工程指示 / 要求簡箋(E.I.)

工程指示編號 : EI / 5945 23 修改版次 :
 工程編號 : J - 858 工程名稱 : 將軍澳 w 日出康城 LP 11
 工程項目 : 幕牆 拆圖修改 廠安防火棉和棉叉
 收件人 : 生統 / 水洪 / 王良 / 拆圖 發件人 : Ant Yeung 日期 : 30/03/2023

工程指示編號：EI / 5527 / 23 (原 EI 5272) 修改版次：L
 工程編號：J - 858 工程名稱：將軍澳日出康城 LP 11
 工程項目：幕牆 大貨單元件加工圖 防火棉 以此為準
 收件人：生統 / 王良 / 水洪 發件人：Ant Yeung 日期：20/02/2023

Subject: **Site Observation for Matter on Fire Isolation Installation and Other Issues at 12/F BD of T1**

名稱	47工架	制圖	曾建平	2017.06.03	修改		
材料	1.5mm 鋁	復核	王健	2017.06.03	日期	J858-MC1	
顏色	MILL	批准			圖號	J858 MC1

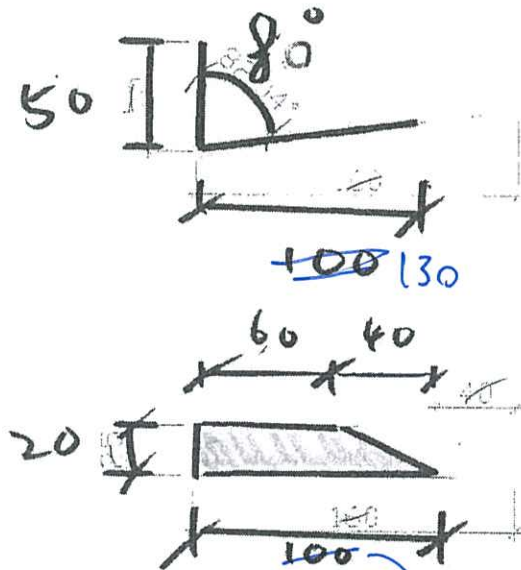
凡有飾線的單元件, 防火棉需由廠安裝時。

需要加棉叉才能固定, 避免運輸時脫落。

請修改拆圖有飾線的單元件, 需用棉叉固定防火棉。

附棉叉參考相片,

請統計使用數量, 預 300 中至中

生統: 請先生產 200 件來供 T2 單元件先使用。

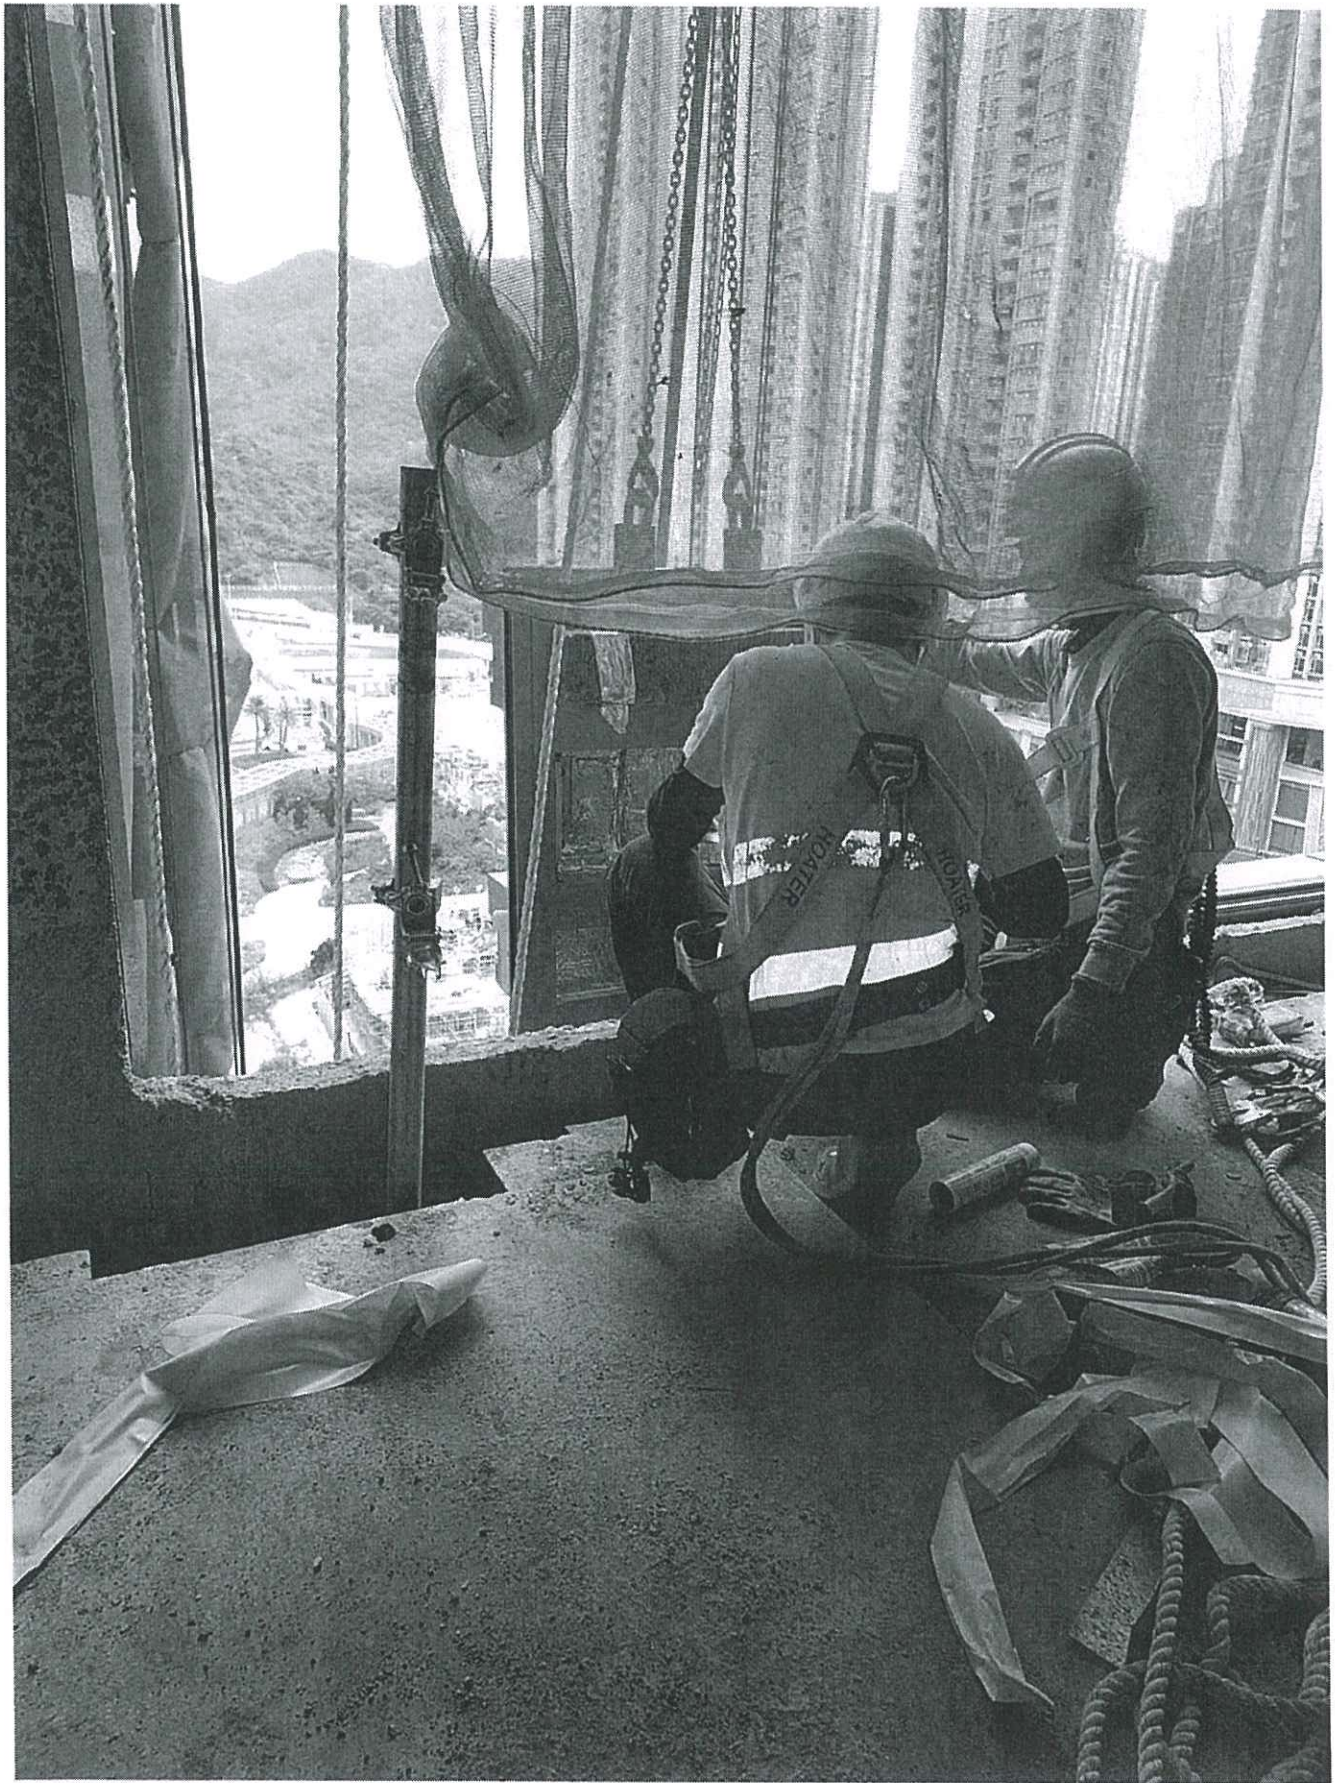
L 版：因應地盆安裝時，原本在地盆安裝的防火棉托，會阻礙安裝有飾線的單元件。

所以凡有飾線的單元件此防火棉需改由廠安裝。顧問已同意。(附報告)

*請留意 防火棉需貼上錫紙，錫紙包好(完整)，翻不露出防火棉。

*單元件落架：因防火棉墊高，請留意高低。

參考相片，該個飾線背空間全裝密，單元背凸出30MM便可以，唔夠地盤後補

↓ 需用锡纸包好
完整

Photo 1

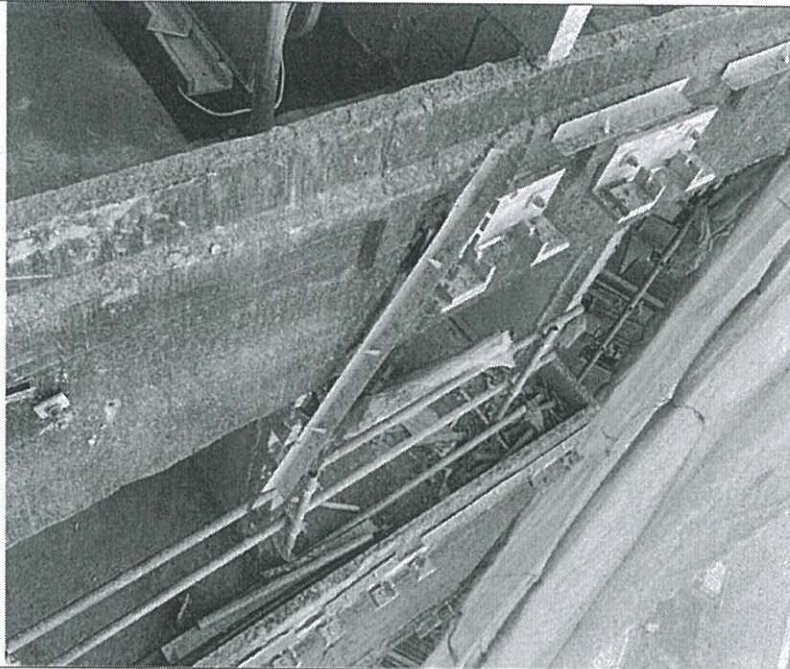
The retainer plate for fire insulation was observed to be damaged on the 12/F slab. It was removed after informed of MIDI.

Photo 3

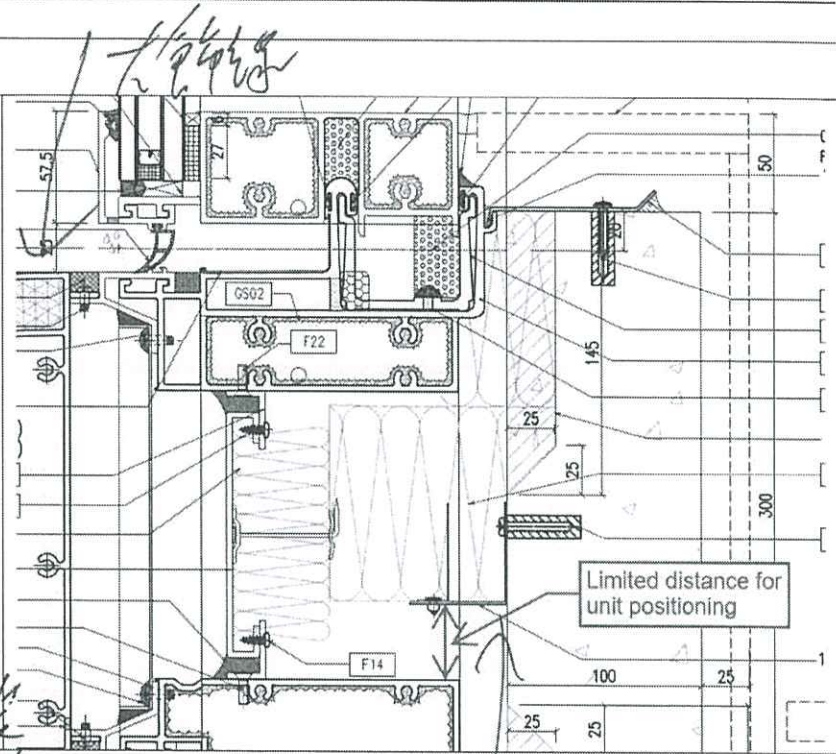
The retainer plate will clash with unit due to it limits unit movement for positioning.

It was coordinated and agreed that the fire insulation was pre-mounted onto spandrel position for formal installation.

需用錫紙包好 (7/2 示範)
(穿管包好, 不穿管不包)

Photo 7

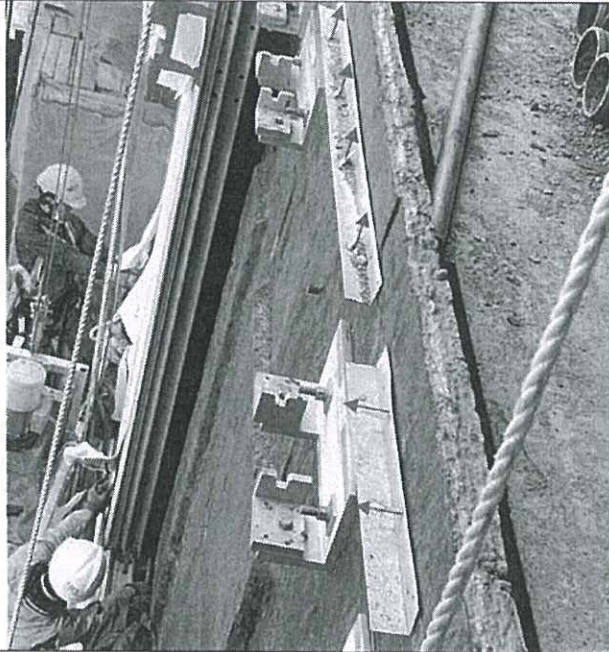
The installed retainer plate was observed to be with different orientation.

有關工廠新預裝防火棉

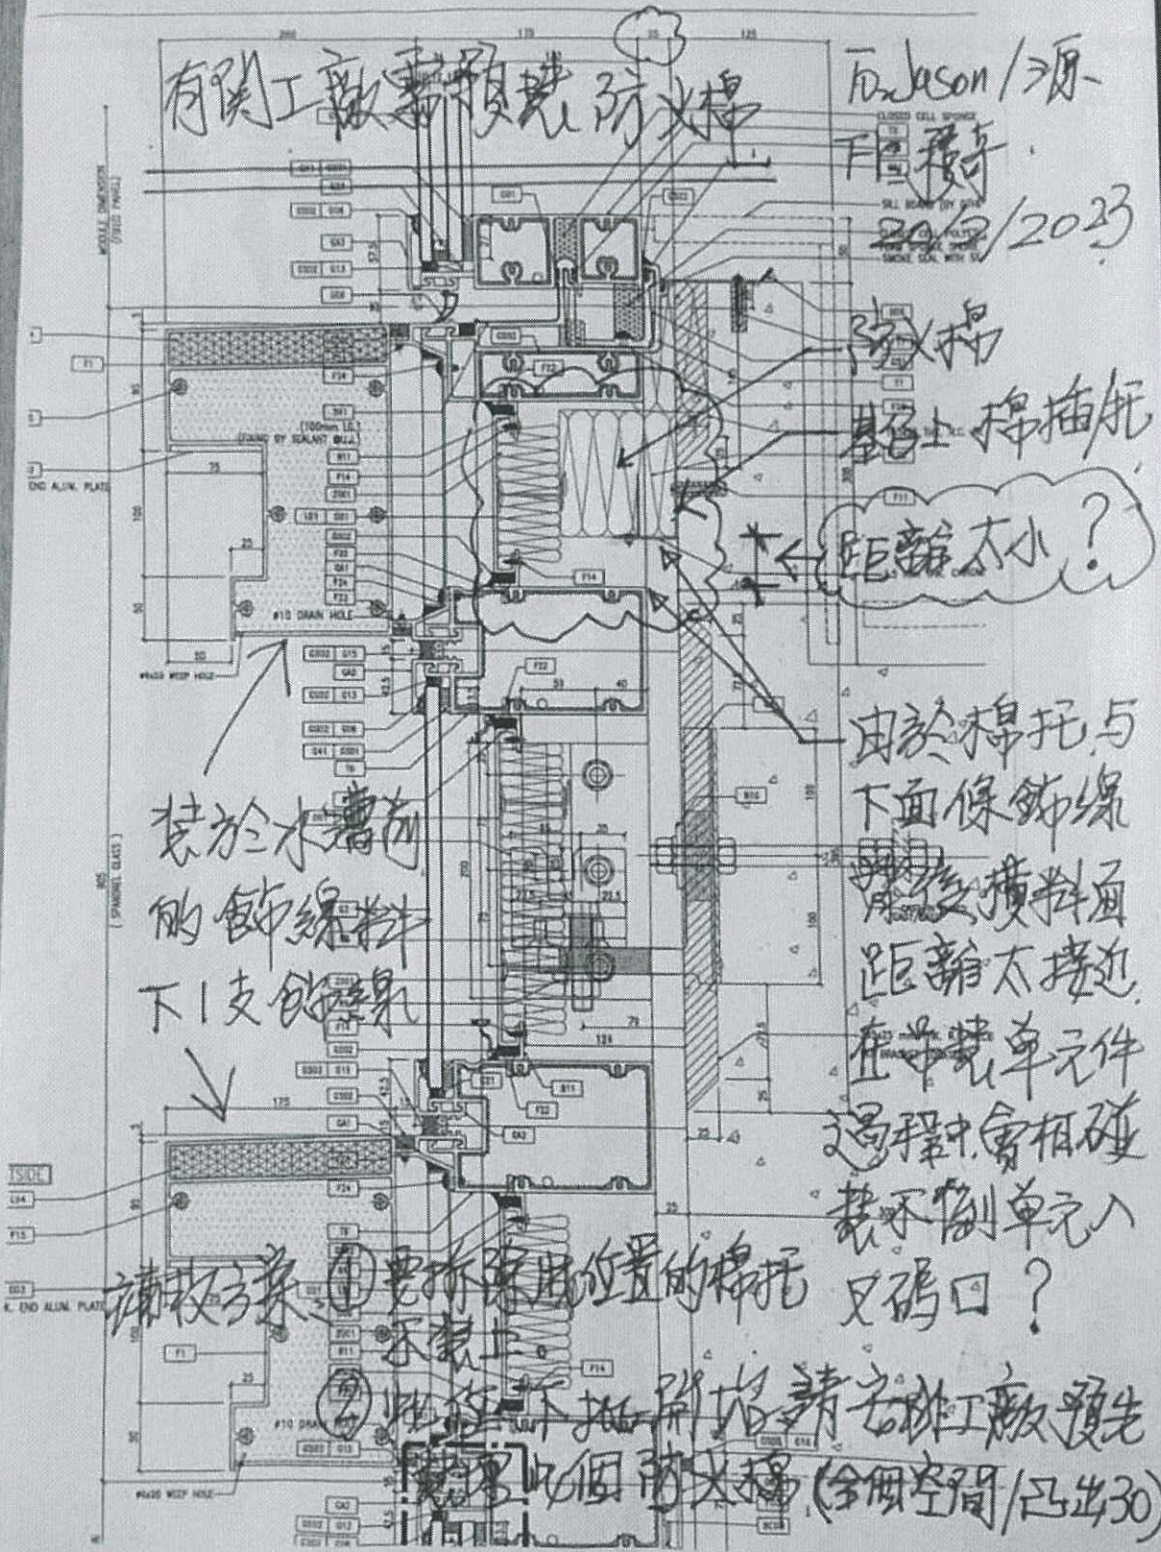
防火棉
墊上棉插死

← 距離太小?

由於棉托與
下面條飾線
間後橫料面
距離太接近
在安裝單元
過程中會相碰
裝不到單元入
只碼口?

請收線
① 要拆裝用位置的棉托
不裝上

② 此條下批預裝請告知工廠預先
預留此個防火棉 (合個空間/凸出30)
